**STATE OF RHODE ISLAND AND PROVIDENCE PLANTATIONS  
PUBLIC UTILITIES COMMISSION**

THE NARRAGANSETT ELECTRIC	:	
COMPANY d/b/a NATIONAL GRID'S	:	
NEED TO CONSTRUCT AND ALTER	:	PUC Docket No. 4614
CERTAIN TRANSMISSION COMPONENTS	:	
IN THE TOWNS OF PORTSMOUTH AND	:	
MIDDLETOWN (AQUIDNECK ISLAND	:	
RELIABILITY PROJECT)	:

**NATIONAL GRID'S RESPONSE TO THE  
RHODE ISLAND DIVISION OF PUBLIC UTILITIES'  
INTERROGATORIES AND REQUESTS FOR PRODUCTION – SET II**

PLAN OF LAND FOR  
JEPSON SUBSTATION  
SITUATED ON  
JEPSON LANE  
MIDDLETOWN & PORTSMOUTH  
RHODE ISLAND  
PREPARED FOR  
NATIONAL GRID

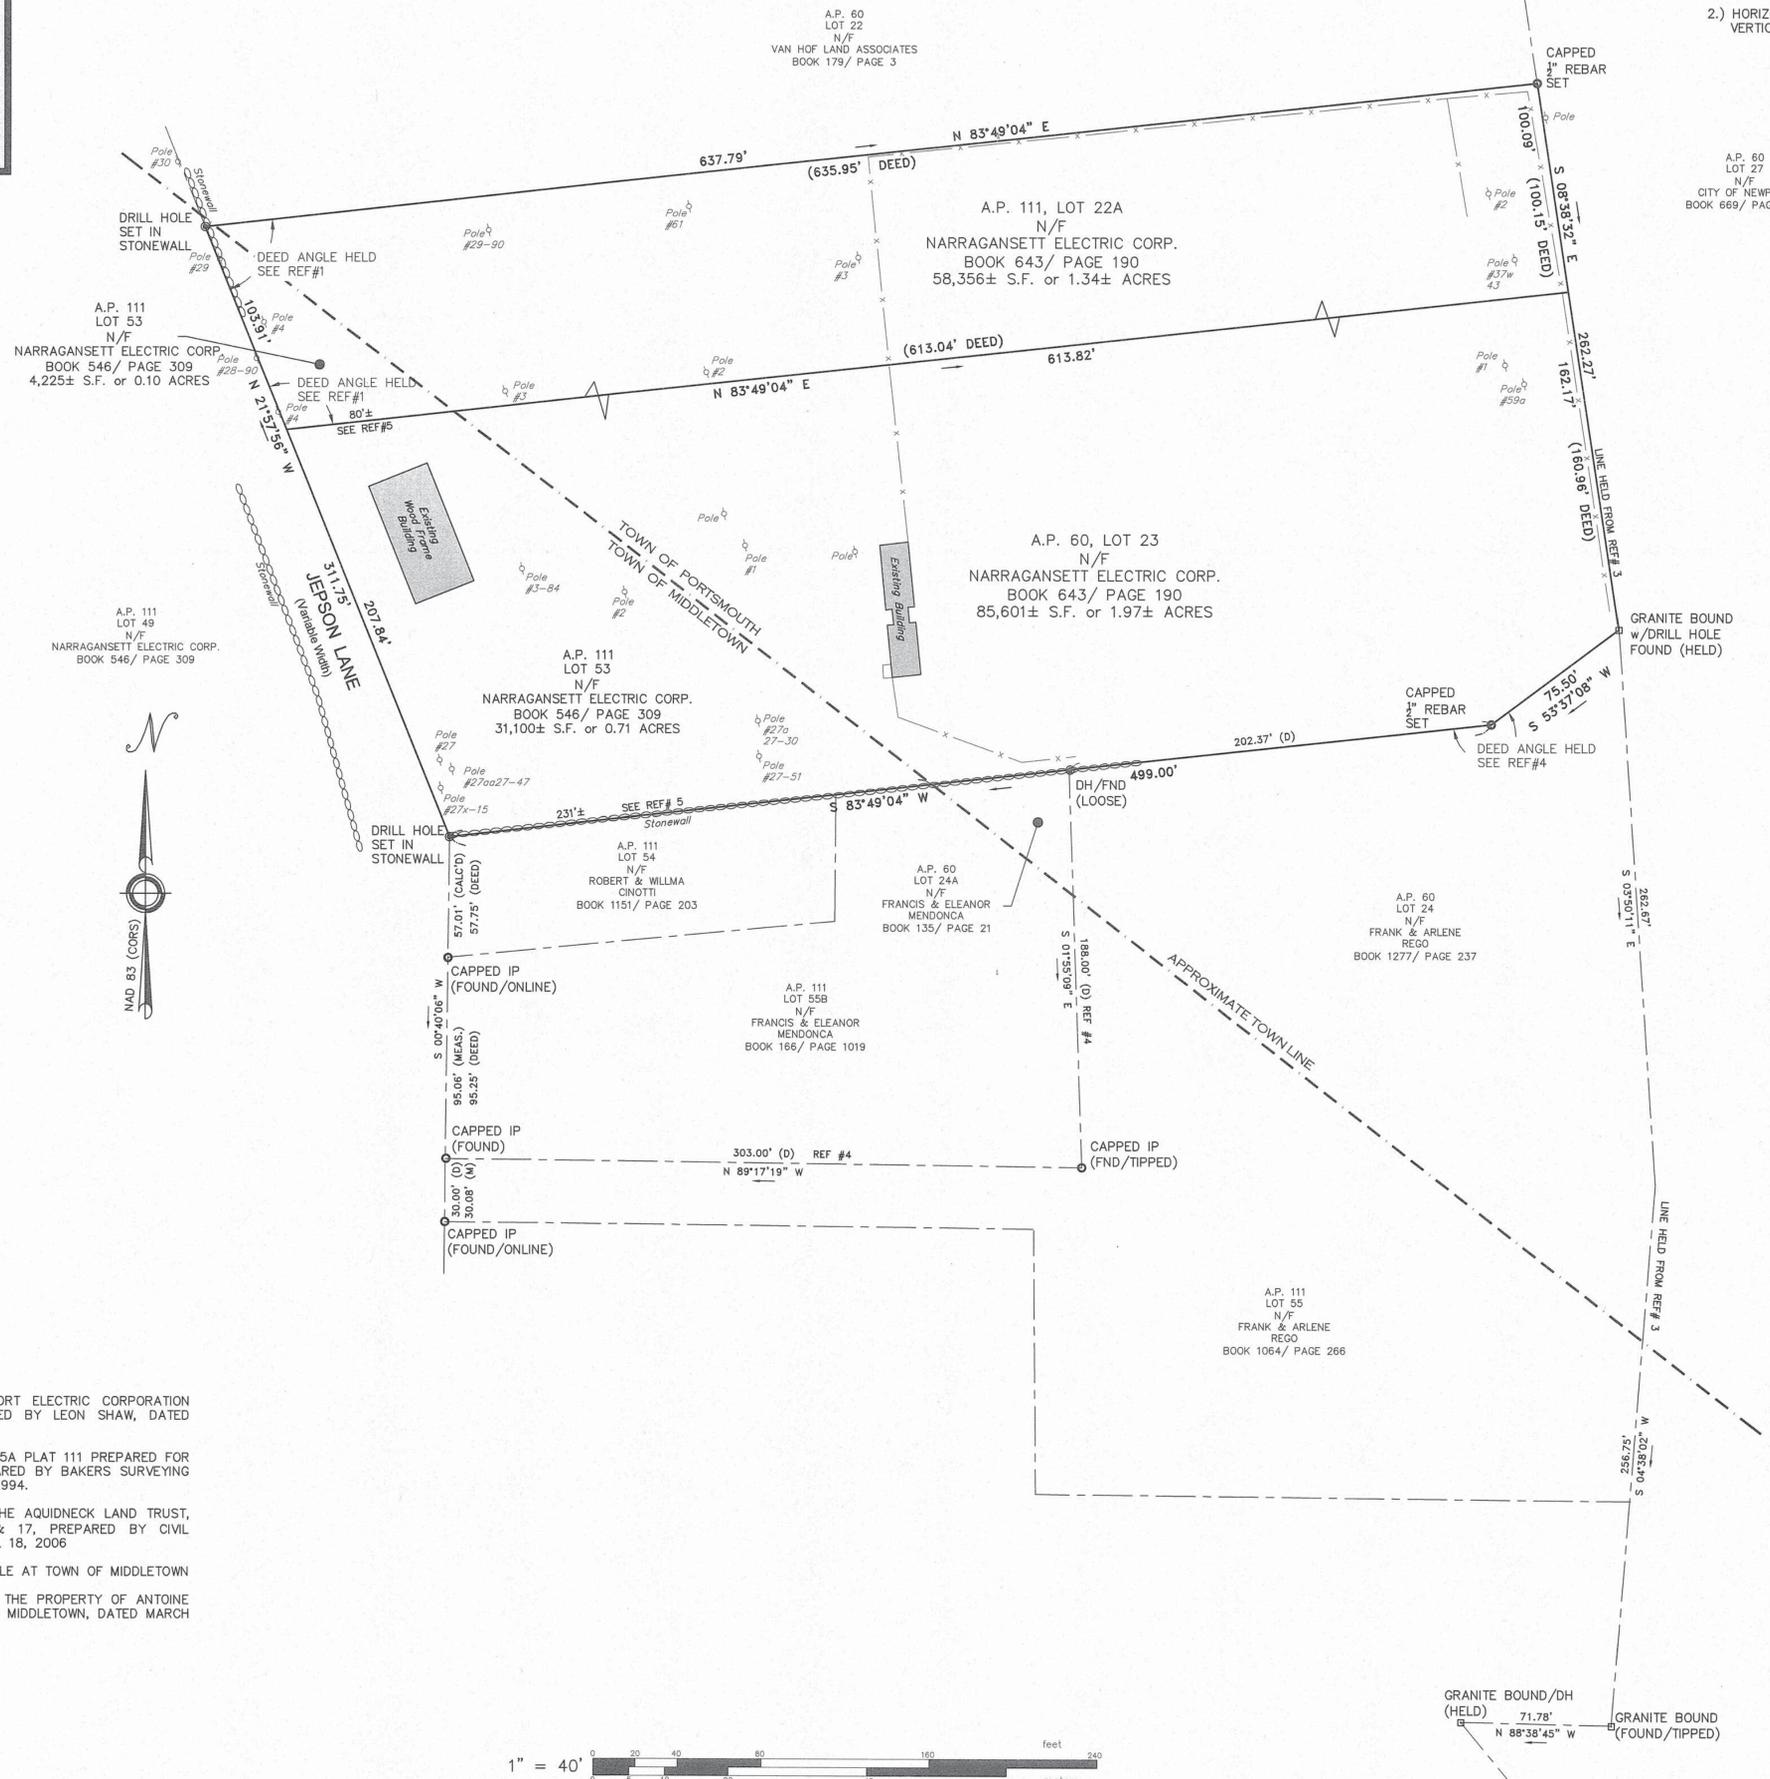
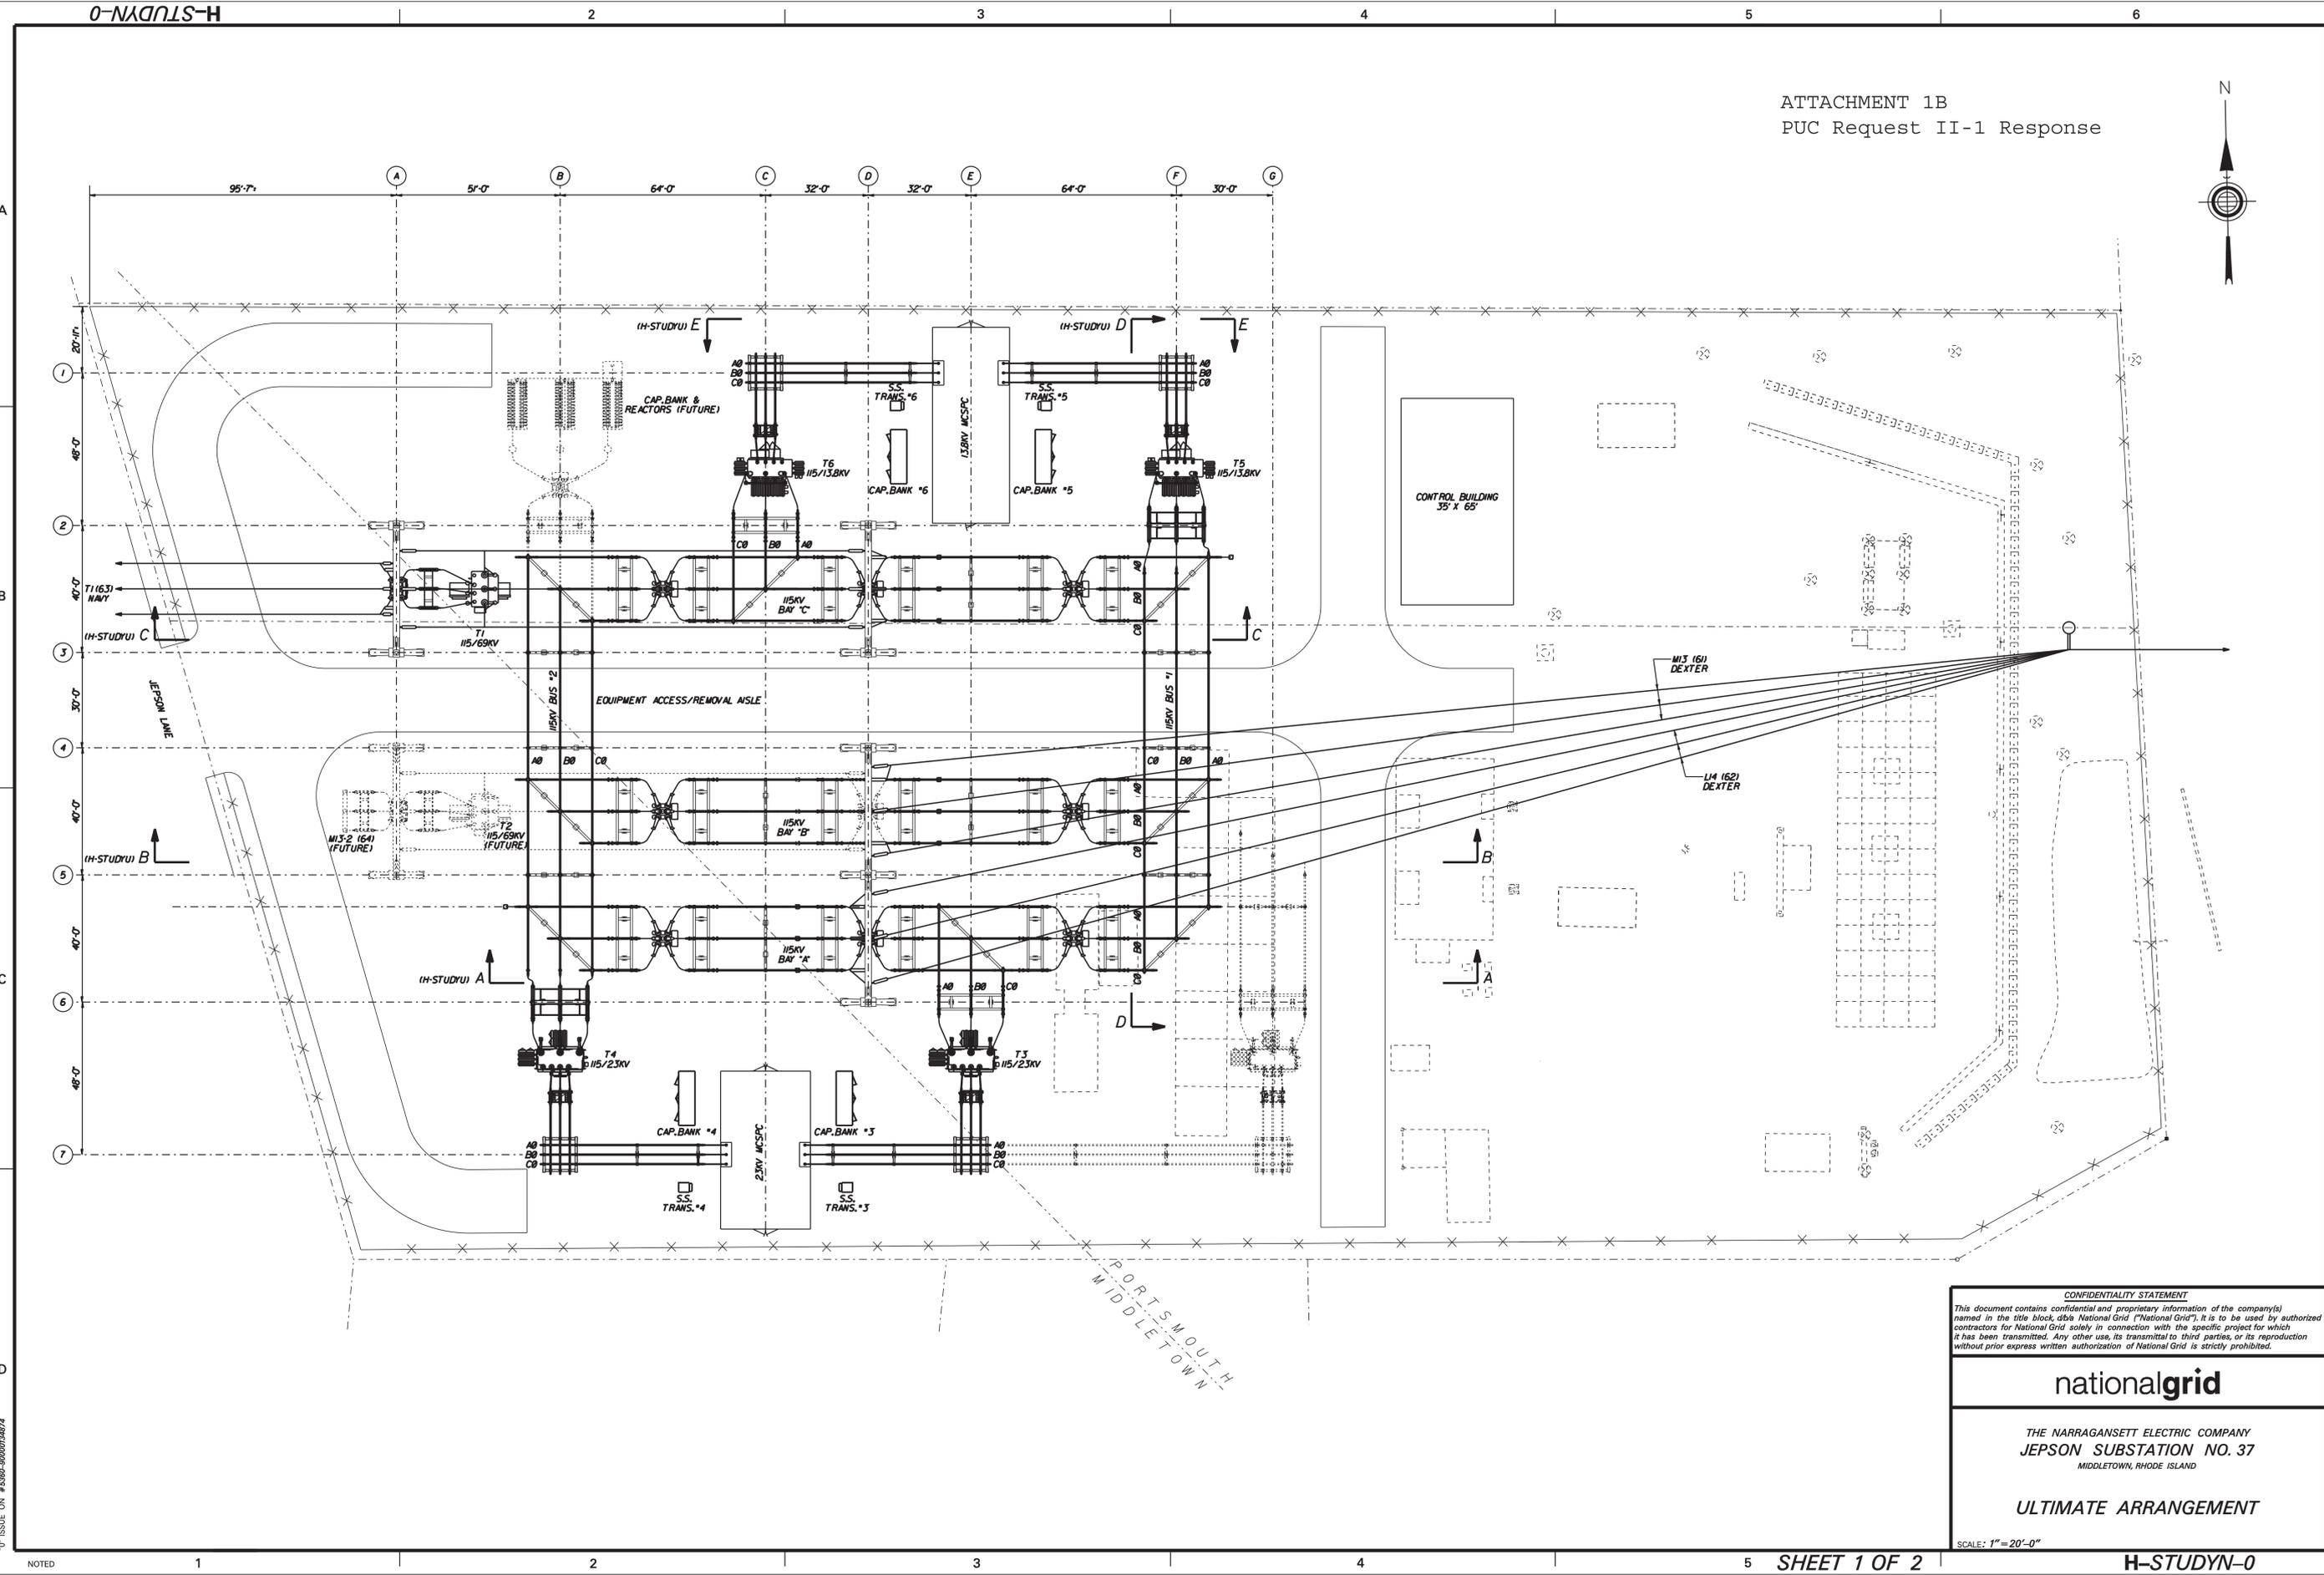
**REQUEST NO. R-II-1:** Regarding the reuse of the exiting Jepson Substation site (see Witness Fiku testimony, page 5), please provide all study material and support documents developed to determine that the existing site would be rejected, including substation layout, cost estimates, parcel maps indicating boundaries of currently owned property and adjacent property for sale, and topography maps.

**RESPONSE NO. 1:** Attached is the property plan of the existing substation site titled “PLAN OF LAND FOR JEPSON SUBSTATION SITUATED ON JEPSON LANE MIDDLETOWN & PORTSMOUTH RHODE ISLAND PREPARED FOR NATIONAL GRID” drawn by Garofalo & Associates, Inc. dated December 8, 2009 (Attachment 1A) and two substation layouts titled “THE NARRAGANSETT ELECTRIC COMPANY JEPSON SUBSTATION NO. 37 MIDDLETOWN, RHODE ISLAND ULTIMATE ARRANGEMENT H-*STUDYN-0*” (“H-*STUDYN-0*”) (Attachment 1B) and “THE NARRAGANSETT ELECTRIC COMPANY JEPSON SUBSTATION NO. 37 MIDDLETOWN, RHODE ISLAND ULTIMATE ARRANGEMENT H-*STUDYP-0*” (“H-*STUDYP-0*”) (Attachment 1C) developed to evaluate this site for the new substation. The first layout, H-*STUDYN-0*, was a conventional all overhead conductor substation. This option was rejected for the reasons listed in Section 5.4.1 of the Environmental Report (“ER”). These reasons include space restrictions, complexity of construction sequencing and outage scheduling working close to an energized station as well as multiple temporary line relocations that would be required. In an effort to address some of these

The property to the north of the existing substation is for sale. However the development rights were previously sold to the State of Rhode Island and cannot be used for anything but agricultural purposes. The Company reviewed as part of its research into this alternative the attached Deed to Development Rights dated December 12, 1989 and recorded in Book 237 Page 19 of the Town of Portsmouth Land Evidence Records (Attachment 1G).
